# City of Surrey PLANNING & DEVELOPMENT REPORT File: 7911-0231-00

Planning Report Date: May 28, 2012

in order to permit the development of a 3-storey mixed-use building.

LOCATION: 5641 - 177B Street

NORTH ELEVATION

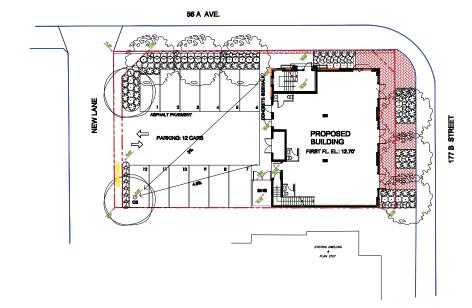
- The bay windows on the third floor project into the setback to allow a comfortable window seat and architectural feature when viewed from the outside.
- The roof projects 0.15 metre (0.5 ft.) beyond the bay window to provide a practical covering detail.
- Although the roof overhang is only 0.08 metre (.26 ft.) from the northeast corner property line, it is 9 metres (30 ft.) above the sidewalk. This projection into the setback should not create any practical problem.
- The canopy provides adequate pedestrian shelter in front of the storefront windows in a style to complement the architectural period.
- The building face encroachment into the front yard setback (in the northeast corner) is minor and amounts to only 0.18 metre (2 sq. ft.).

• The setback to the building face along all four property lines complies with the setback requirements of the C-15 Zone, with the exception of the minor encroachment on the upper two floors in the northeast corner of the building. The visible impact of this encroachment is negligible.

- Due to road dedication for the corner cut, the roof overhang spans close to the property line at the northeast corner of the site. Excluding the setback to the northeast corner of the property, the roof overhang is set back approximately 1.4 metres (4.6 ft.) from the east property line and 1.75 metres (5.7 ft.) from the north property line. This varies slightly from the 2.0-metre (7 ft.) setback requirement of the C-15 Zone for these two property lines.

- Excluding the setback to the northeast corner of the property, the setback to the glass canopy from the north and east property lines is approximately 0.9 metre (3 ft.). This encroachment appears reasonable given the value the canopy adds towards the appearance of the building and for weather protection.

- The Zoning By-law permits encroachments up to 0.6 metre (2.0 ft.) for roof overhangs and bay windows provided they do not exceed a total of 2.4 metres (8 ft.) in horizontal length along any exterior wall. The proposed bay windows encroach no more than 0.55 metre (1.8 ft.) into the setbacks, however, the bay windows slightly exceed 2.4 metres (8 ft.) in horizontal length.

- Staff support the requested variances.
